Access Compliance Report

Public Rights-of-Way

Intersection ID: 26828	Main Street: ALEXA_RD	Cross Street: OAK_POND_CR	Location: NW
ADA ID: 635FCA43075D	Ramp Type: BlendTrans1	Initial Pass/Fail: Fail	Overall Compliance: No
			Severity Score: 21.25

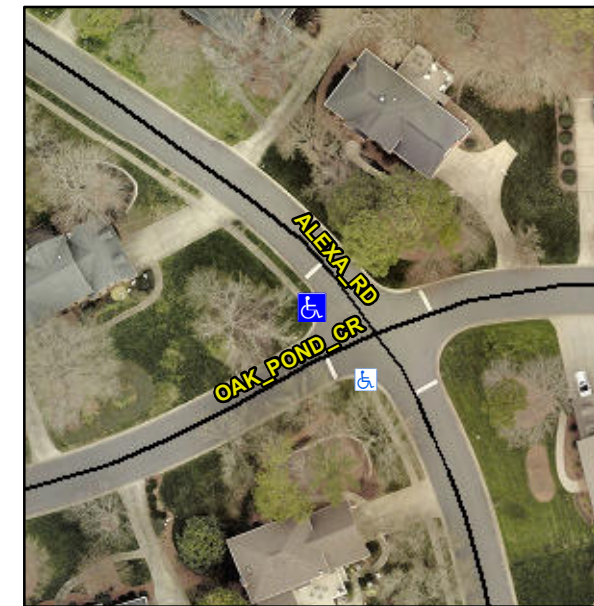
R304.5.1, R304.5.3

Compliance	Description	Data	Compliance	Description	Data
N/A	Ramp Length (in)	48.0	Yes	BlendTrans Slope (%)	2.5
No	Ramp Width (in)	41.0	No	BlendTrans XSlope (%)	5.7
N/A	Flare Type LT	N/A	N/A	Flare Type RT	N/A
N/A	Flare Slope LT (%)	N/A	N/A	Flare Slope RT (%)	N/A
N/A	Flare Traversable LT?	N/A	N/A	Flare Traversable RT?	N/A
N/A	Landing Length (in)	N/A	N/A	DWS Provided?	N/A
N/A	Landing Width (in)	N/A	N/A	DWS Contrast?	N/A
N/A	Landing Slope (%)	N/A	N/A	DWS Length (in)	N/A
N/A	Landing X Slope (%)	N/A	N/A	DWS Full Width?	N/A
N/A	Landing Curb? (Y/N)	N/A	N/A	DWS Offset (in)	N/A
N/A	Shared Landing?	N/A			
N/A	Gutter Ponding?	N/A	N/A	Gutter Slope (%)	N/A
N/A	Gutter Lip Ht (in)	N/A	N/A	Gutter X Slope (%)	N/A
N/A	Painted X Walk1?	No	N/A	Painted X Walk2?	No
	X Walk 1 Direction	To SE		X Walk 2 Direction	To NE
	X Walk 1 Width (in)	N/A		X Walk 2 Width (in)	N/A
	X Walk 1 Slope (%)	4.7		X Walk 2 Slope (%)	3.6
	X Walk 1 X Slope (%)	1.7		X Walk 2 X Slope (%)	4.1

Remove & Replace Curb Ramp With Two New Directional Ramps or Equivalent.
